PROJECT: Our Lady of Mount Carmel, Blackley

Repair Proposal - North Aisle / Abutment Gutter

A	18.09.23	JW	Purpose of issue updated to construction and notes updated to reflect updated scope of work following tender
Rev	Date	Int	Description

Sectional Elevation through abutment gutter (Nave North Elevation)

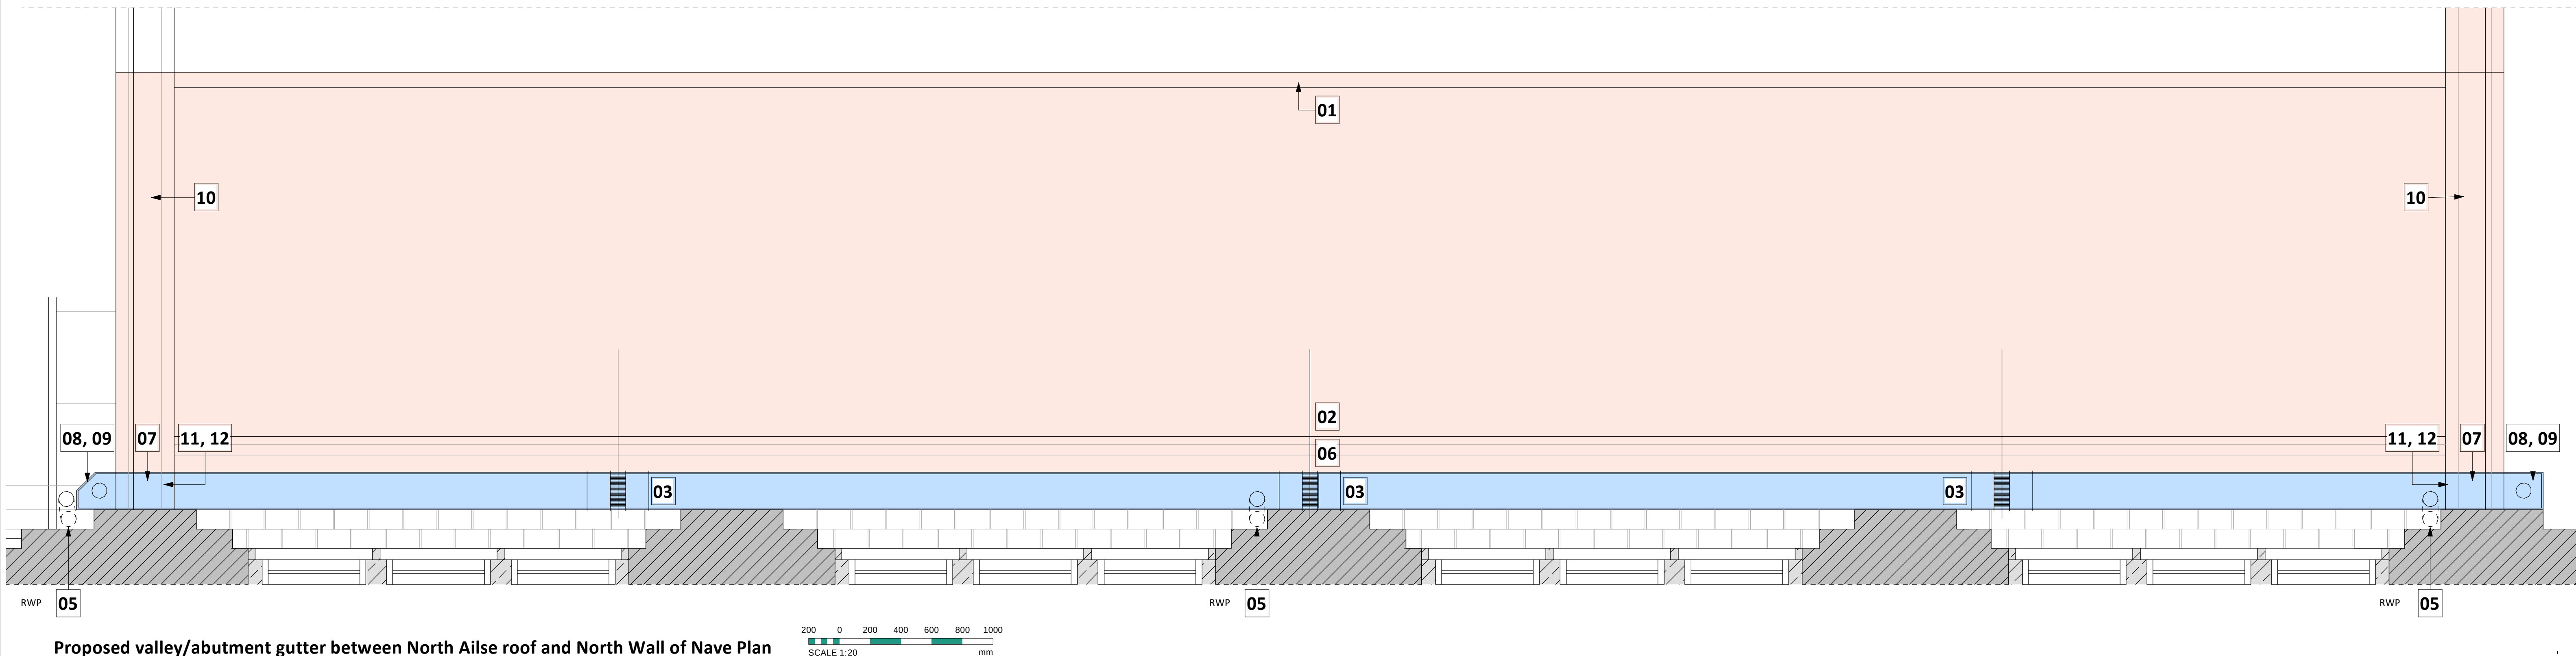
02 3no. courses of (REV A) the existing slate roof finish to North Aisle southside to be carefully stripped back to existing substrate/ roof joists. Include for removal of Ubblex temporary repair and for all boarding/ tilting battens at gutter. Assess slates for reuse and sort/ record/ store in safe position. Repair/ renew damaged and rotten areas of boarding/structural timbers as necessary. Lay Proctor's Roofshield breathable underlay in accordance with manufacturer's recommendations, and 50 x 32mm tanalised slating battens to accept re-laid slates in regular courses. Make up any shortfall in reclaimed matching slates, carefully sourced to follow existing in size, texture and edge finish (allow 40%). Minimum slate head lap: 75mm.

06 To roof finish, slates on the *first 3 courses* (REV A) are to be re-laid to allow the formation of an inclined TCSS flashing/impact plate over lower 450mm of roof slope. This is to allow for foot traffic for future maintenance access. Flashing to be dressed a minimum 75m down into gutter and secured with clips at maximum 450mm centres along loose edge of flashing. Flashing to be then dressed up over new sarking boards to form the inclined section of impact plate and then over the new tilting fillet/sarking boards before being dressed over the first slating batten. Battens and tilting fillet locations are to be set out and approved by the architect prior to fixing.
